**FILE NO. 1090 FINAL PLAT APPROVAL – WOODCREEK**

**BUSINESS PARK RESUBDIVISION NO. 2;** Property is located at the southwest corner of Butterfield Road and Woodcreek Drive, commonly known as 2211 Butterfield Road, Downers Grove, IL (PIN 05-25-414-010, and -011); James F. Miller, JFM Enterprises, Inc., Owner/ Petitioner  
May 16, 2003

**TO:** Kenneth J. Rathje, AICP, Director of Planning  
**FROM:** Michael D. Millette, P.E., Asst. Director of Public Works – Engineering *ADM*  
Jonathan Hall, P.E., Development Engineering Manager *JH*  
**DATE:** April 30, 2003  
**RE:** American Chartered Bank Public Works Plan Review Comments  
for May Plan Commission Meeting

**TO:** Kenneth J. Rathje, Director of Planning  
**FROM:** Michael D. Millette, P.E., Asst. Director of Public Works – Engineering  
Jonathan Hall, P.E., Development Engineering Manager  
**DATE:** May 29, 2003  
**RE:** Woodcreek Business Park Resubdivision No. 2  
(American Chartered Bank) Public Works Plat Review Comments

**Project Review Comments**      **American Chartered Bank**  
**Department: Public Works As of 04/11/03**      **Preliminary Plans Dated 03/05/03**

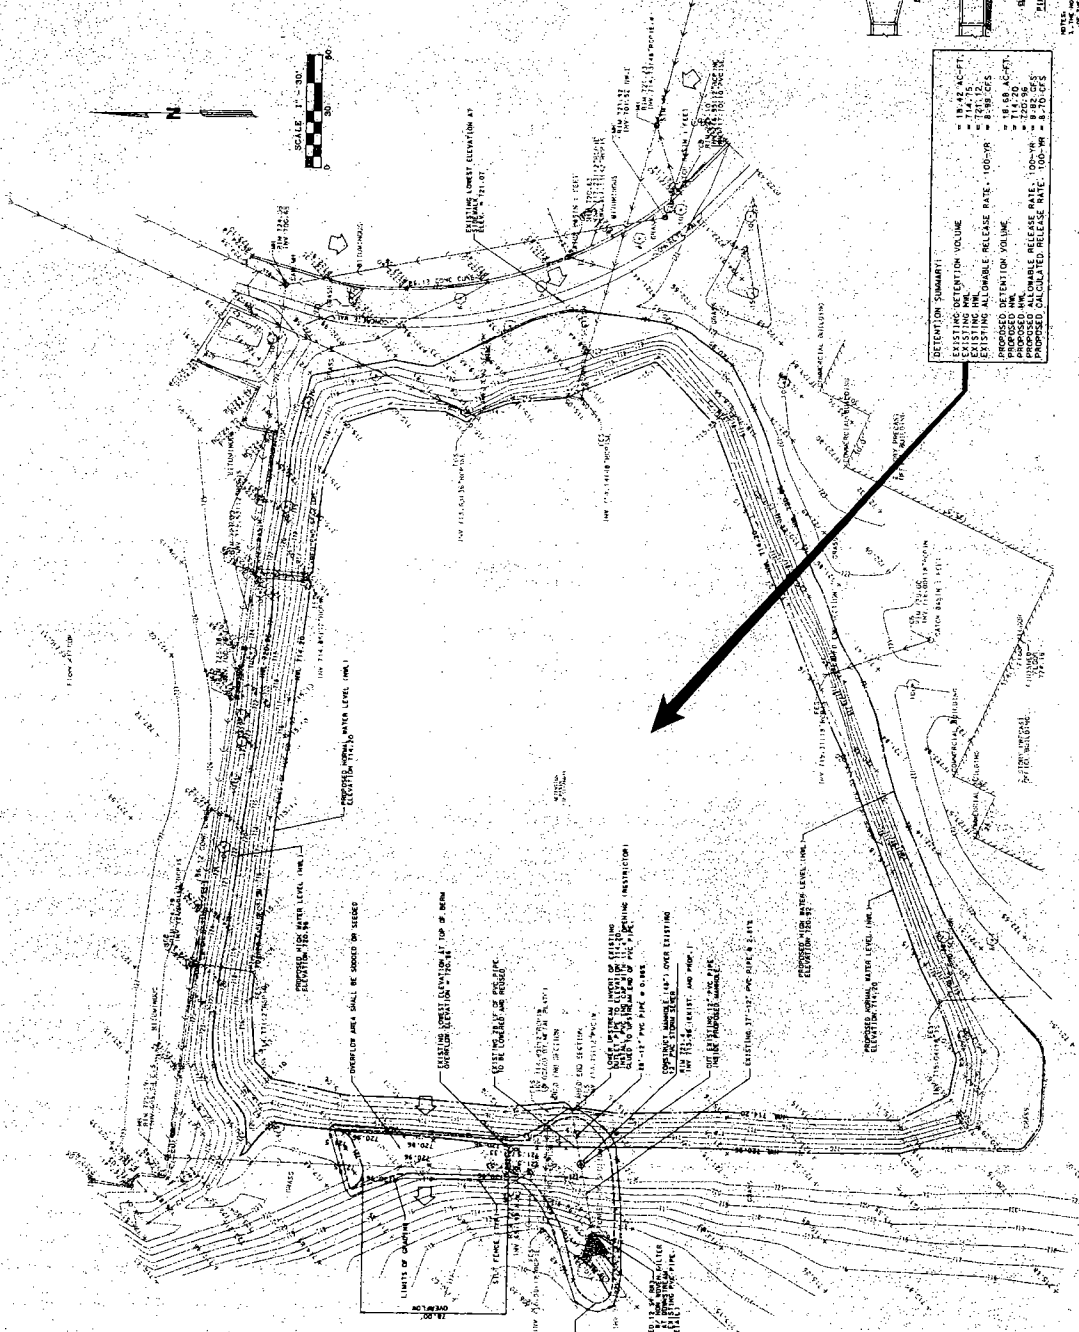
1	1	1	Contact Information	Delete phone and fax numbers for Village Hall and replace with correct numbers. Phone: 630.434.5500 Fax: 630.434.5571	BP
2	5	Storm Manhole	Notation	Add "Core drill existing manhole" note to existing manhole located at the southeast corner of Wood Creek Drive and access road to bank driveway entrance.	BP
3	5	Water Main	Notation	Add "(See Detail)" to water service note.	BP
4	5	Water Main	Notation	Add "5' Dia. Vault" and "(See Detail)" to pressure connection note.	BP
5	5	Storm Catch Basin	Notation	Add "Type A" note to Catch Basins #1, #2 and #3.	BP
6	6	Detail	Bituminous Pavement Detail	Add pavement detail for driveway approach on the Public ROW side. It should show a 6" crushed stone base course with an 8" bituminous surface course (6" binder and 2" surface).	BP
7	8	Detail	Water B-box Detail	Add additional notes to detail. See marked up plan sheet.	BP
8	8	Detail	Valve Vault Detail	Delete Valve Vault detail and replace with Village pressure connection detail. (See attached detail drawing)	BP

9	8	Detail	Clean out Detail	Add pipe material type and size to detail notes. (i.e. 4" PVC, 4" DIP, RCP) Provide information clarifying where and how the underdrain is to be located on the utility plan. What storm manhole will it be connected to with a cored drilled connection.	BP
10	9	Reference Spec. A	Spec. #1	Add "Downers Grove" to USGS Datum note.	BP
11	9	General Notes C	Spec. #10	Add "for water main" and "for storm sewer" to part C note.	BP
12	9	General Notes C	Spec. #15	Delete "demolition" and add "all" to note.	BP
13	9	Traffic Control	Spec. #4	Add Item #4 to list stating that Type 1 barricades shall be affixed with a 10" x 15" informative "SIDEWALK CLOSED AHEAD" sign, which shall be placed at either end of the block, nearest the adjoining crosswalk location, for all areas of sidewalk excavation.	BP
14	Plat of Subdiv.		Plat	Add easements for storm sewers and water main on Lot 1.	JH
15	Plat of Subdiv.		Plat	Check with sanitary district for sanitary sewer easement requirements on Lot 1 and Lot 2.	JH

16	Plat of Subdiv.		Plat	Revise covenant language on Sheet 2 as follows: Replace the phrase "water detention area easement" with "Stormwater Conveyance Easement."	JH
17	Plat of Subdiv.		Plat	Add the phrase "hereby granted" adjacent to labels for new easements.	JH
18	Plat of Subdiv.		Plat	Revise covenant language on Sheet 2 as follows: Add the phrase " , including storm sewer pipe and structures," under Item 2 after the phrase "Stormwater Conveyance Easement."	JH
